EPR/BB3001FT/V006 Schedule 5 No. 2 – 28/02/2025 Response

Figure 1 – Pre-application Consultation Response

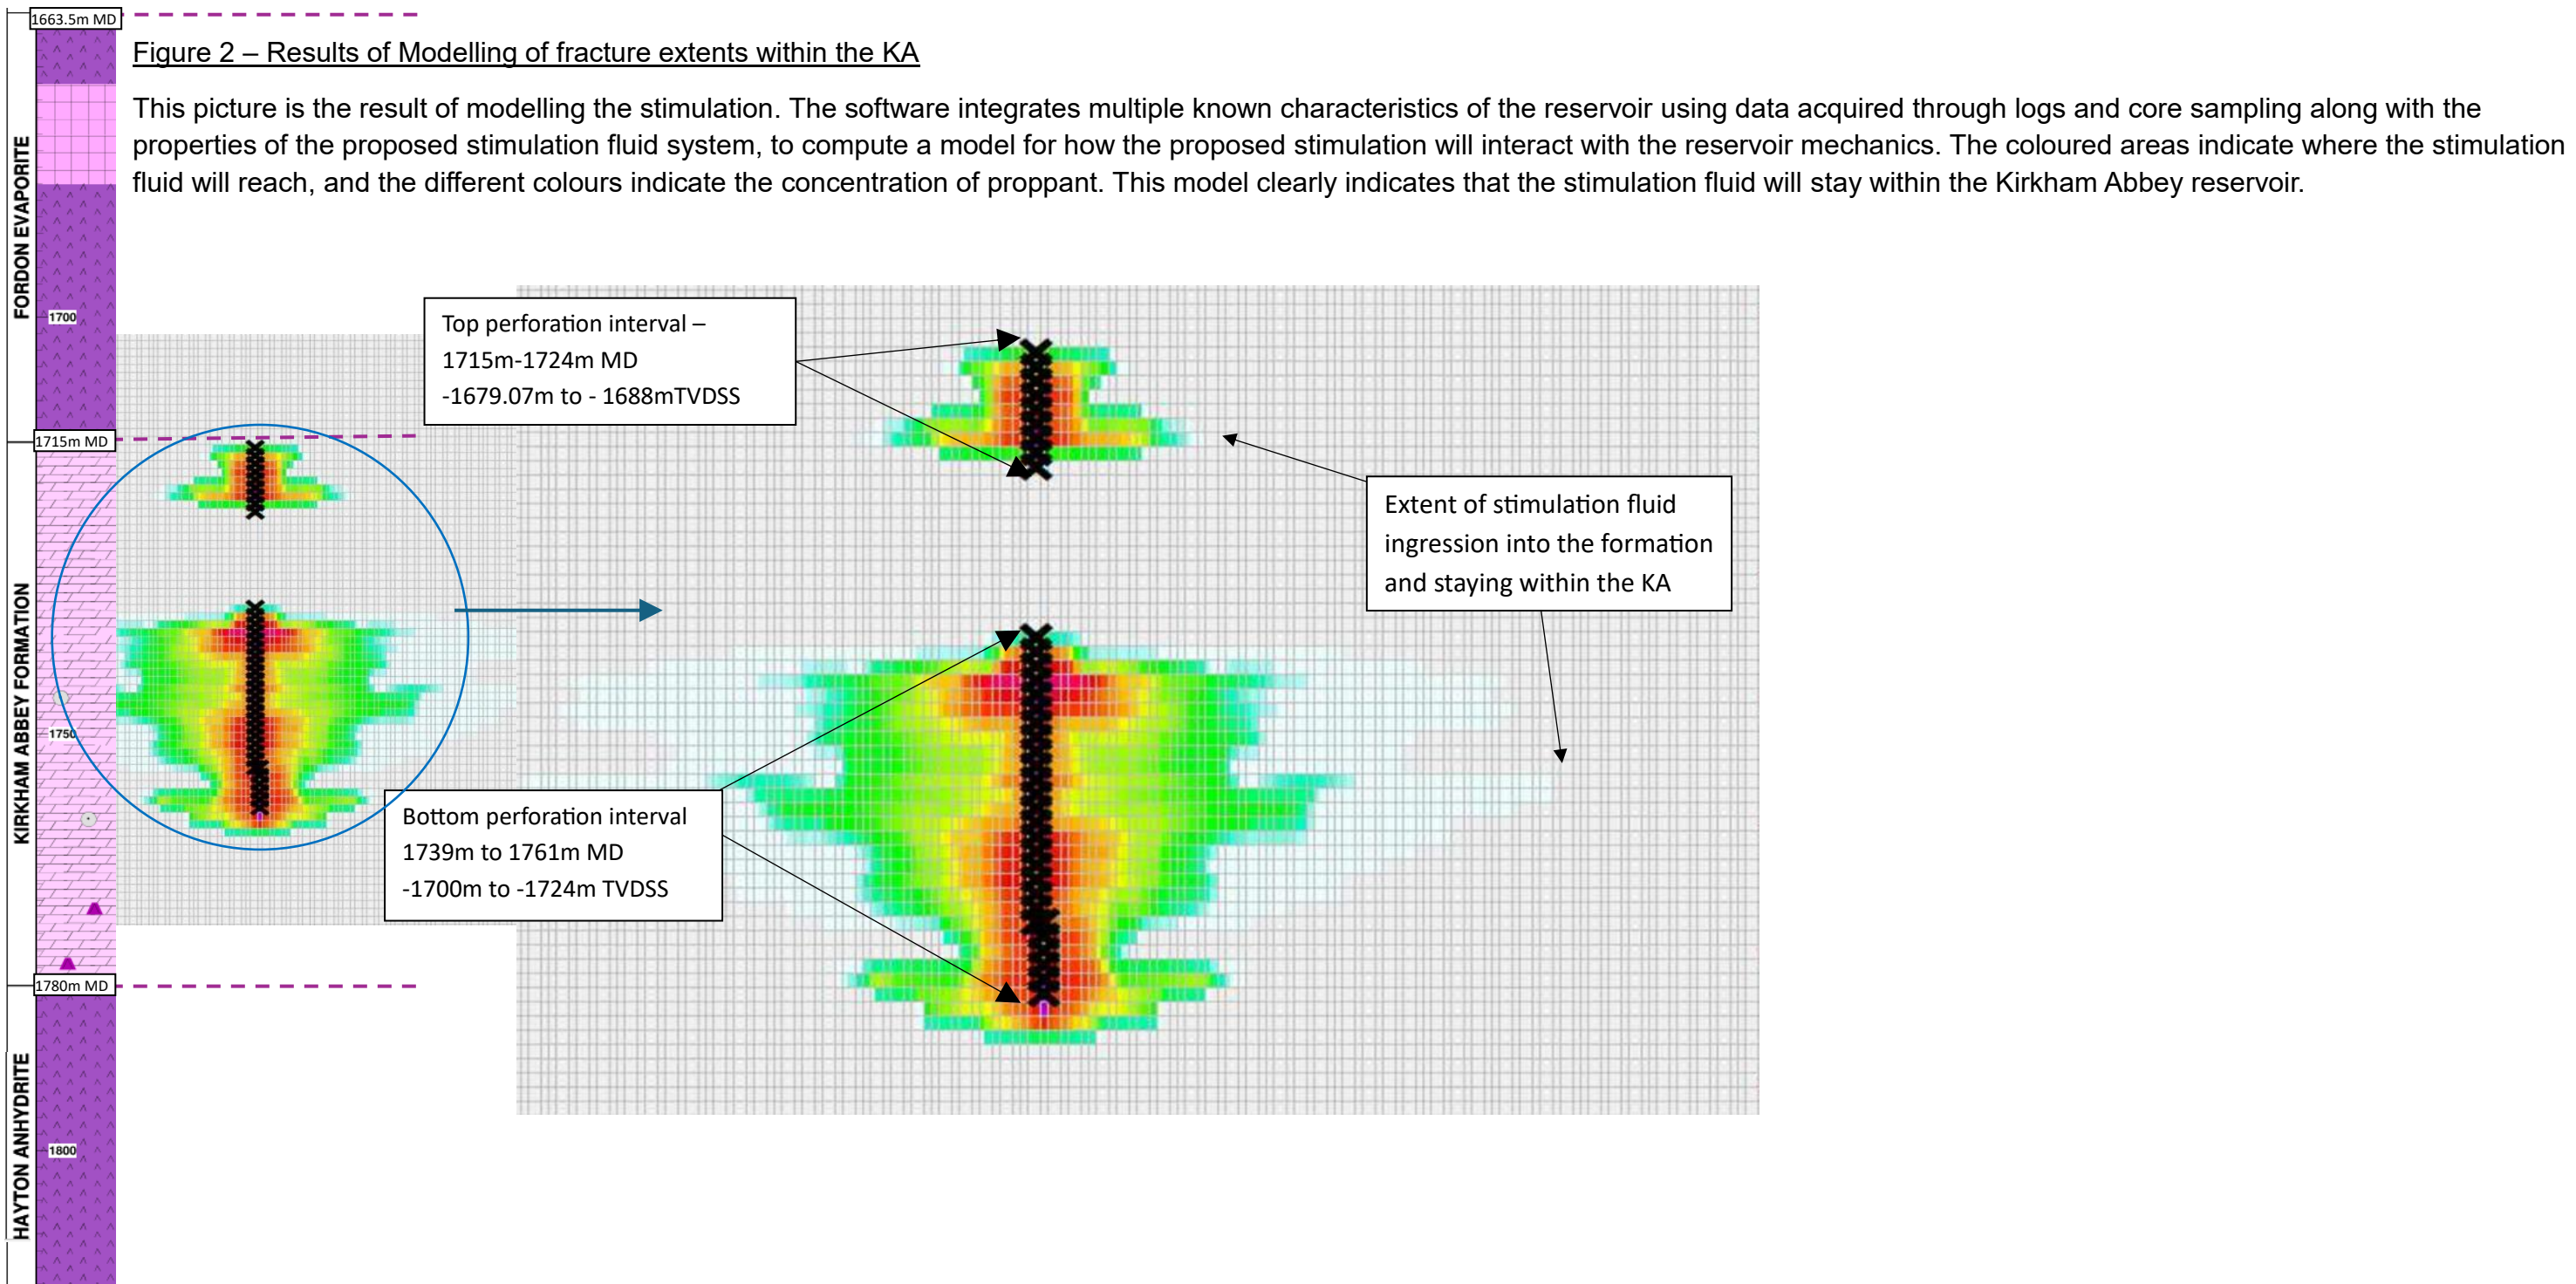
3. Confirm whether a Hydraulic Fracture Plan can be issued to the Environment Agency as a condition (i.e. when the 'Operator' is able to formalise the plan) on the basis, that enough information will be provided to satisfy the requirements for a groundwater activity variation.	Sufficient details are required within the HRA to enable an assessment of the proposals, however, it is recognised that not all information is available to formalise all details of the plan at this stage. Therefore, and in accordance with previous approaches, it would be acceptable to condition the requirement for a Hydraulic fracture plan. The details of the low volume fracking can be dealt within the fracture plan provided as a pre-operational condition as long as there are sufficient details in the HRA to make an assessment.
---	--
